Memorandum

To: Robin Proebsting, Senior Planner
From: Patrick Yamashita, City Engineer
Subject: DSR20-001 (Xing Hua Project, 2885 78th Ave. SE) Street Standards
Date: August 19, 2020

Figure 14 – Town Center Street Standards

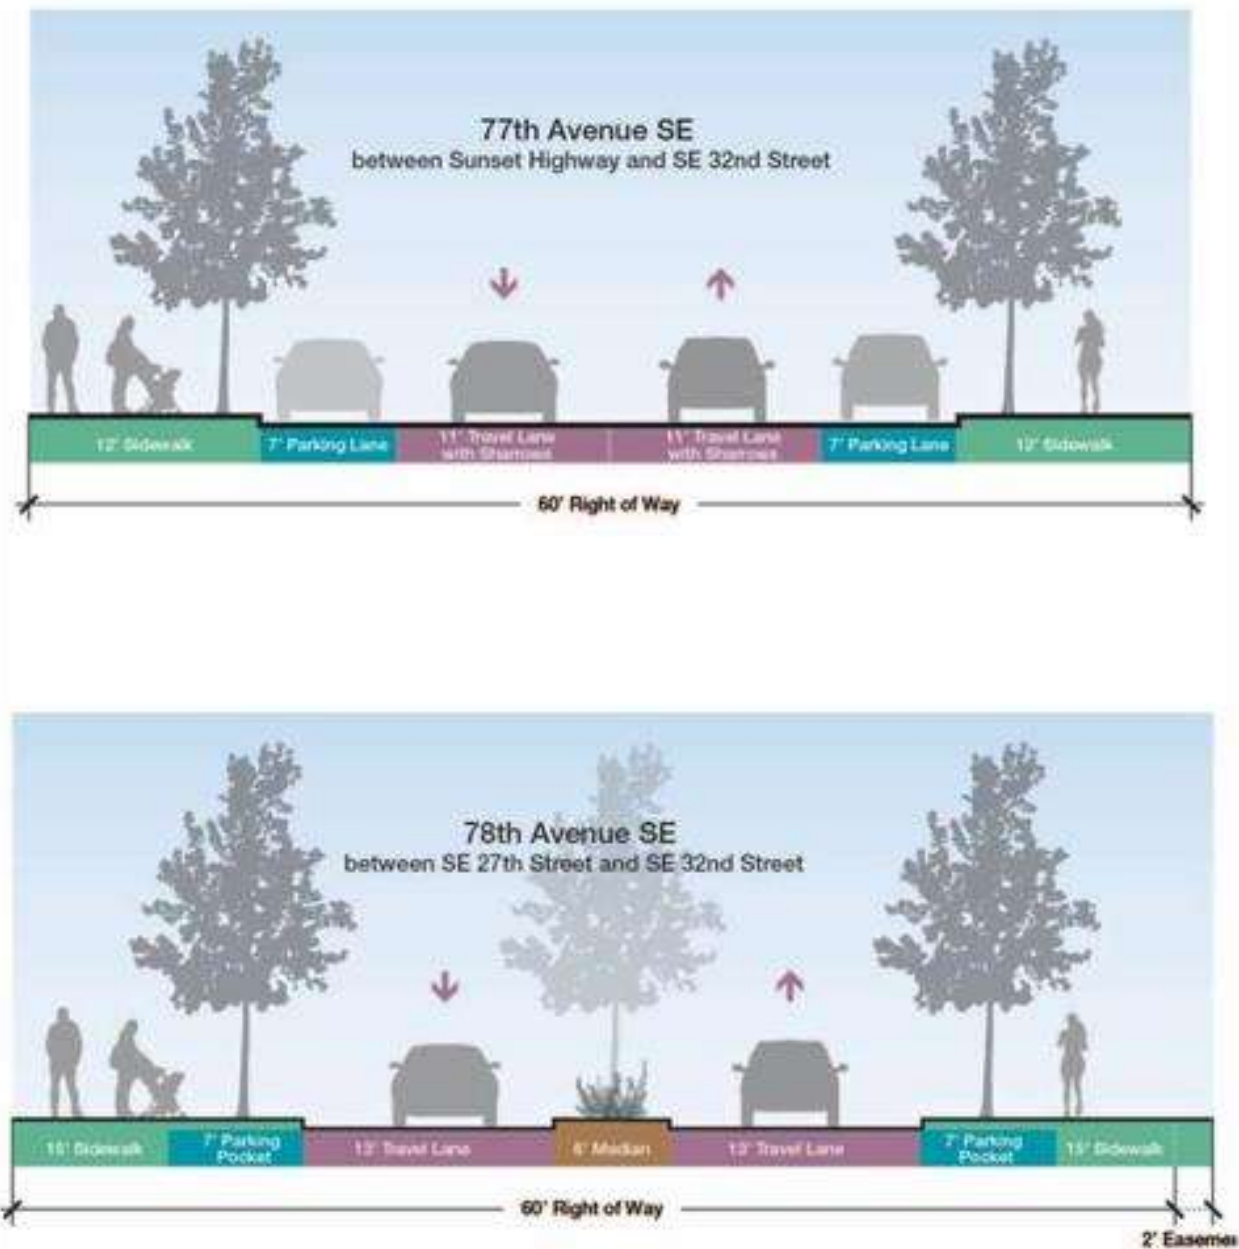
I have reviewed the subject project and have concerns regarding potential unintended consequences of the project complying with the street standards identified in MICC 19.11.120 along their 77th Ave. SE frontage. The standards require conversion of the existing 77th Ave. SE roadway frontage from the existing five lane configuration (one lane in each direction with bike lanes plus center left turn lane) into a four lane configuration (on-street parking and sharrowed lanes (lanes shared between cars and bicycles) in both directions). The code section is provided below for your information:

Xing Hua could meet the street standards through restriping the existing roadway. Their preliminary plans depict such an improvement. However, it makes more sense to improve the entire 77th Ave. SE corridor all at once to provide a consistent treatment rather than a patchwork created by frontage by frontage improvements over time. If Xing Hua builds the street improvements along their short frontage, it will create awkward transitions between existing/new street cross-sections, a piecemeal appearance, impacts to cyclists transitioning into/out of bike lane to sharrow to bike lane, restrict left turning vehicles and yield only a few on-street parking spaces. The City Council adopted a project in the City's Six Year Transportation Improvement Program in June 2020 to make the street improvements along the 77th Ave. SE corridor from North Mercer Way to SE 32nd Street. It is currently programmed for 2026 at an estimated cost of \$58,000. The photo below shows the current configuration of 77th Ave. SE.

I recommend that the Design Commission require payment from Xing Hua to the City their fair share of the future corridor wide street improvements in accordance with the provisions in MICC 19.11.120B and D. The payment would be considered a fee-in-lieu-of constructing the street improvements required by MICC 19.11.120. The amount will be determined by the City Engineer based on a proportionate share of the corridor wide improvements. Payment would be due prior to certificate of occupancy.
